## Planning Commission Staff Report

### Site Plan Case SP-2021-2-Rev1

#### Mainstreet Chrysler Dodge Jeep Ram – Paint Shop

211 Plaza Dr. (Directly West of the Dealership)

1 | site plan  
scale: 1" = 20'-0" north

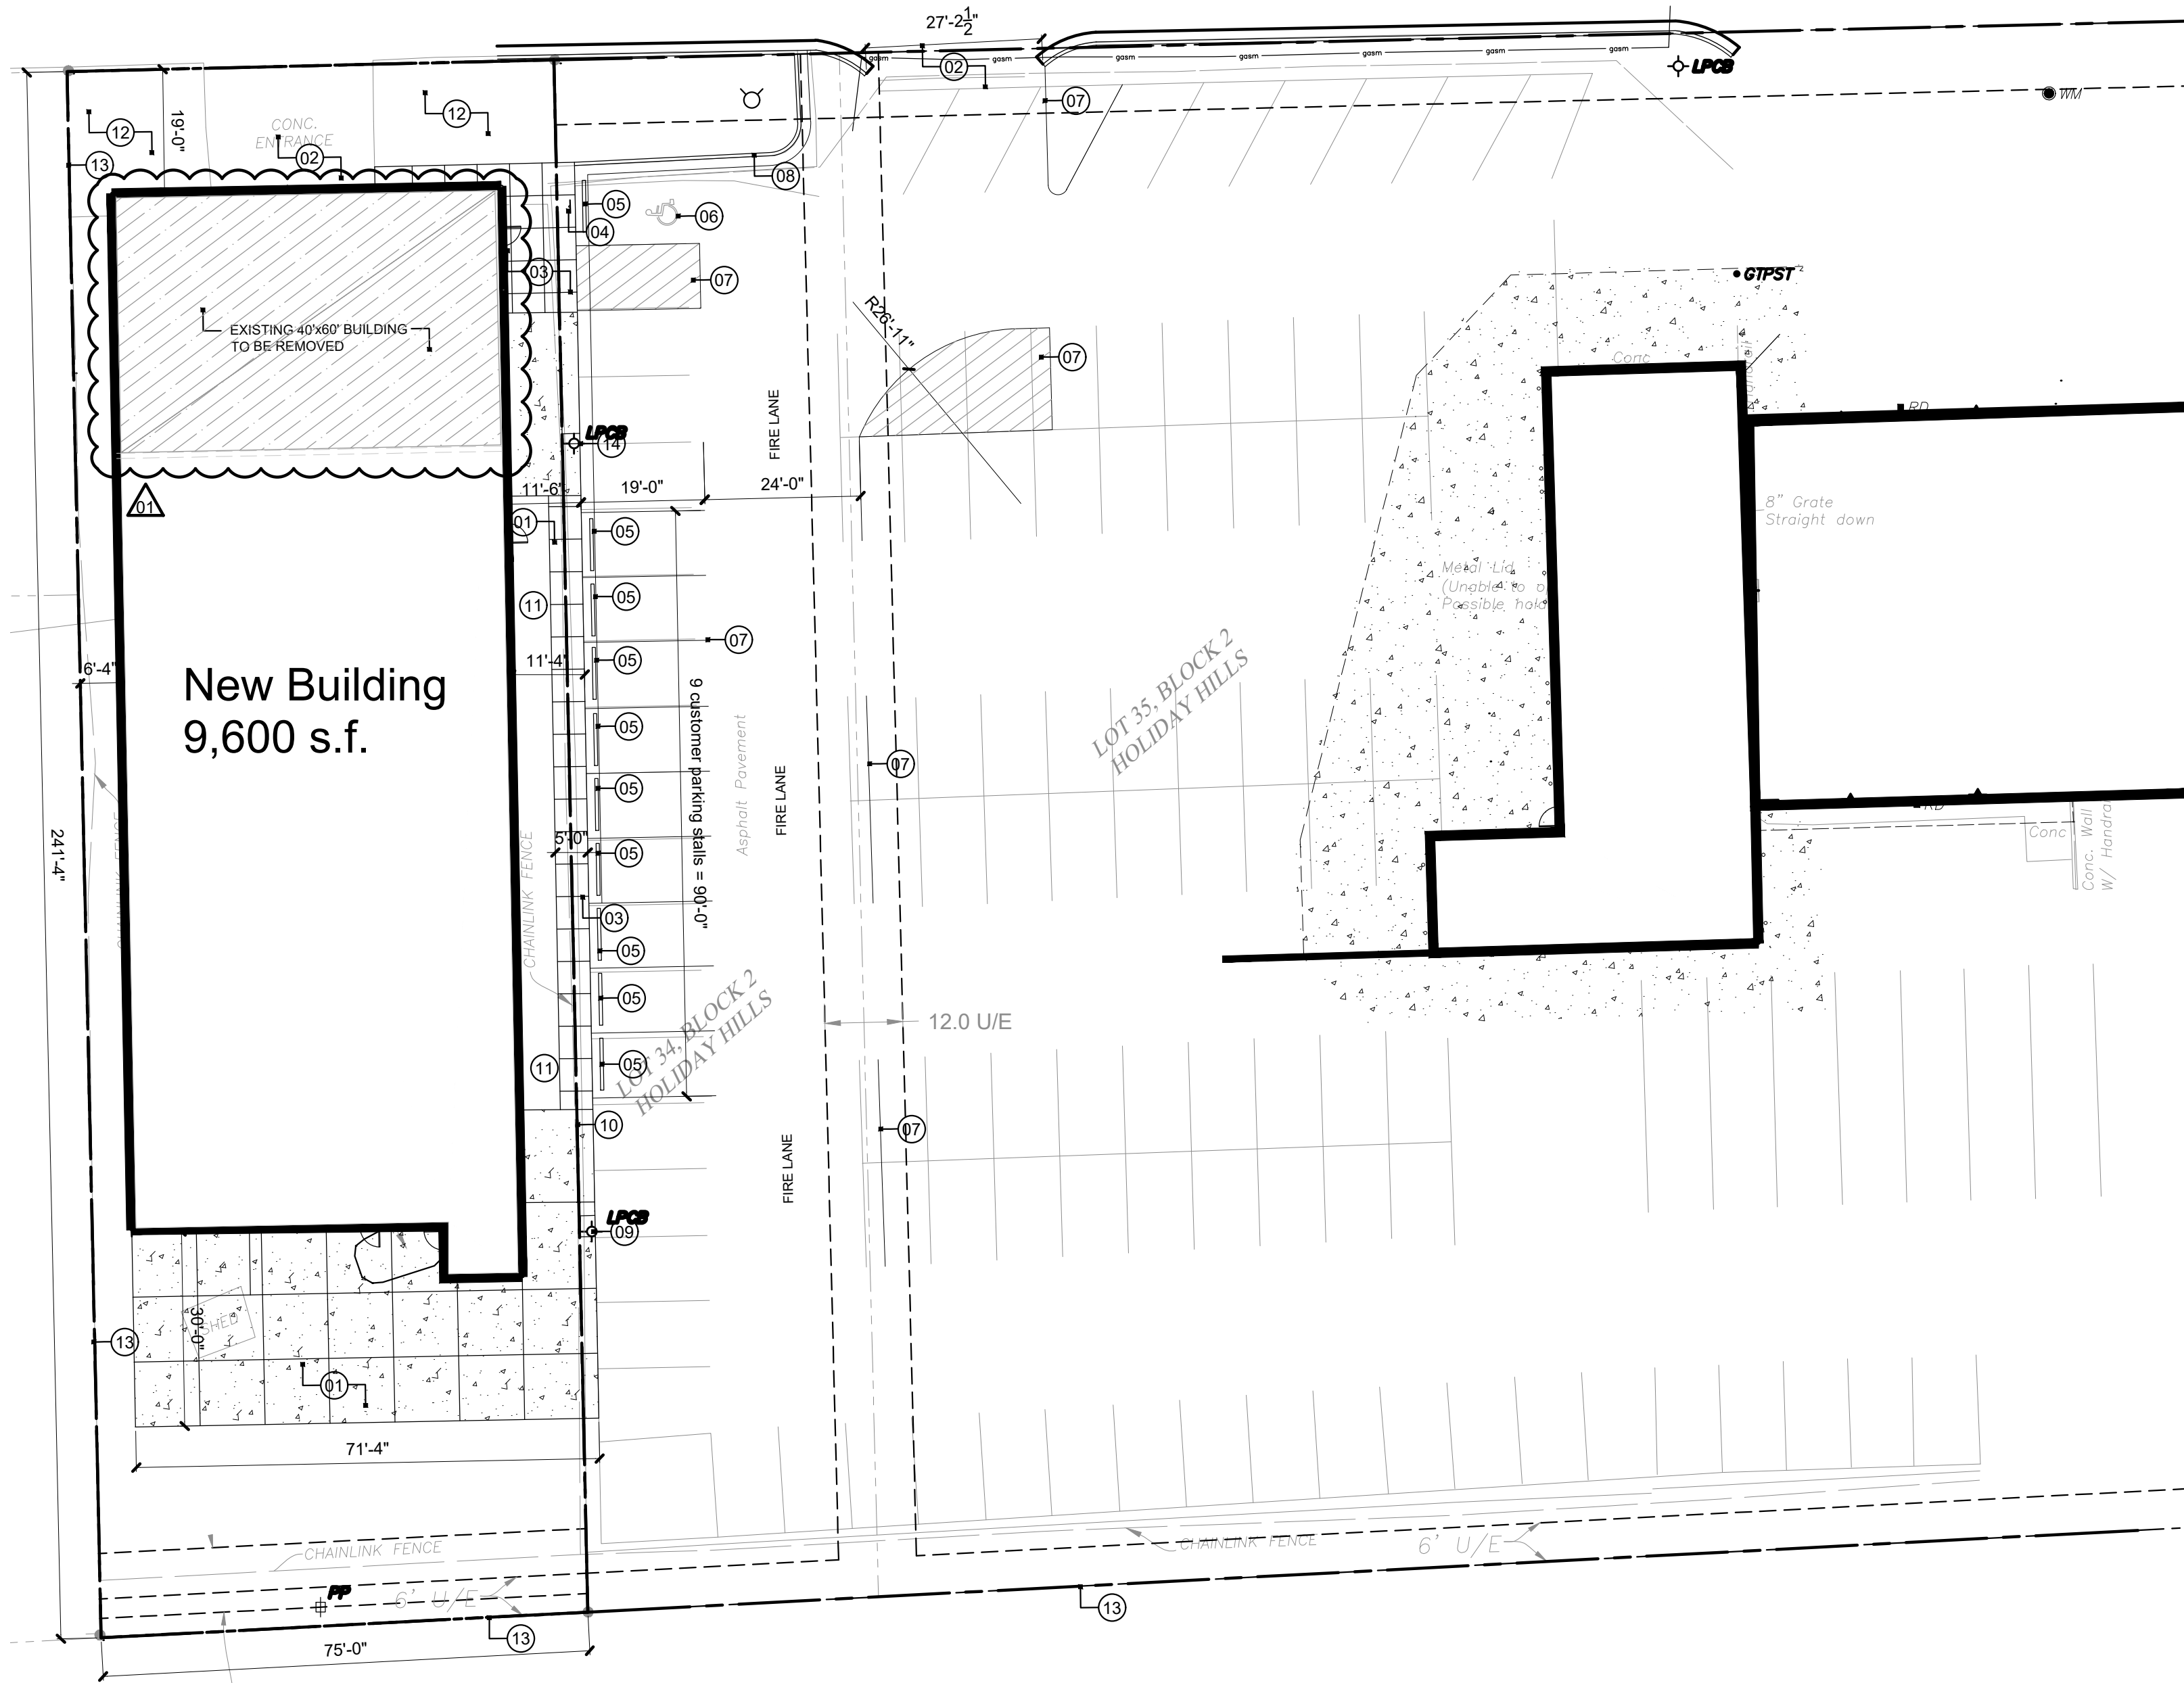
The site plan does not show the current zoning, but the site is zoned as B-3 – Regional Business District per the Lansing Zoning Map.

There is no trash enclosure shown on the proposed development. It is assumed that any needed trash services for the property will either be handled within the building or will utilize the next-door property owned by the same owner.

The Director has worked with Leavenworth County Fire District #1 to obtain approval for the project. The Fire Department has agreed that installing pavement markings on the property to ensure that a fire lane always exists is adequate for this development.
